GeoSolve Ref: 240480.03

3 December 2025

Surface Water and River Engineering Assessment Memo Bendigo-Ophir Gold Project Fast-Track Application Assessment

Figure 3: Underdrain bypass pipe as shown on page 25 of Appendix L (pdf page 156) of document B.06C

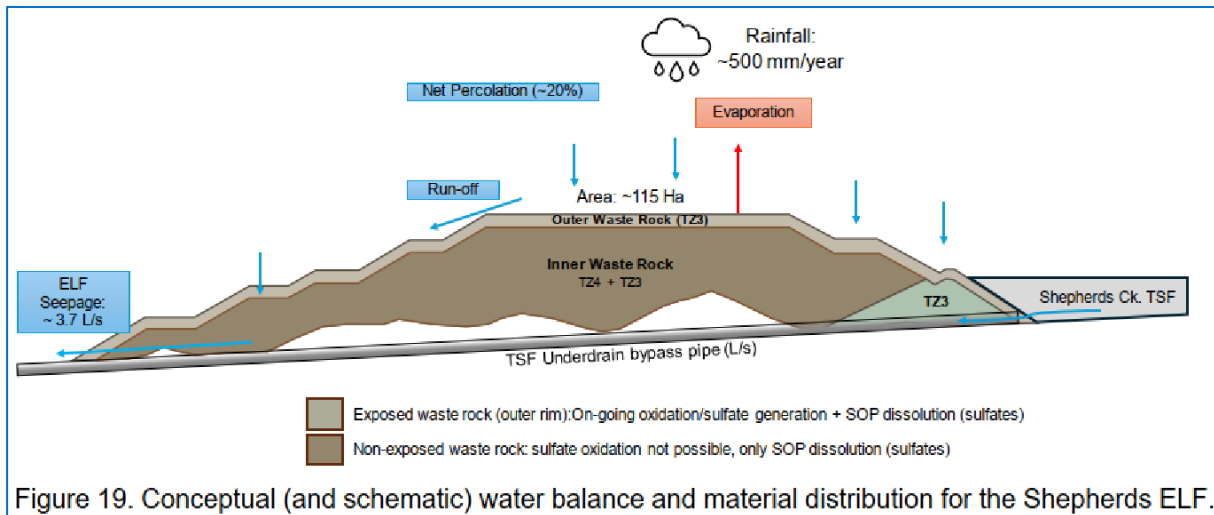
- Document B.04 references the Tailings Storage Facility (TSF) dam design documents prepared by Mine Waste Management (document B.06, including appendices documents B.06 A-C), and GeoSolve has searched these documents for references to the tailings dam. Those documents show that there will be an underdrain bypass pipe under the tailings dam (see Figure 3 below), and it is unclear whether this has been taken into account in Kōmanawa Solutions' estimate of the 50-60 years it will take for the tailings dam to fill. **It is recommended that Kōmanawa Solutions and Mine Waste**

Management’s design & calculation works for the tailings dam are confirmed to be co-ordinated, as this will also affect factors such as dam safety, contaminant transport, monitoring and maintenance and more. It is requested that the applicant confirms this has/will be performed, including details.
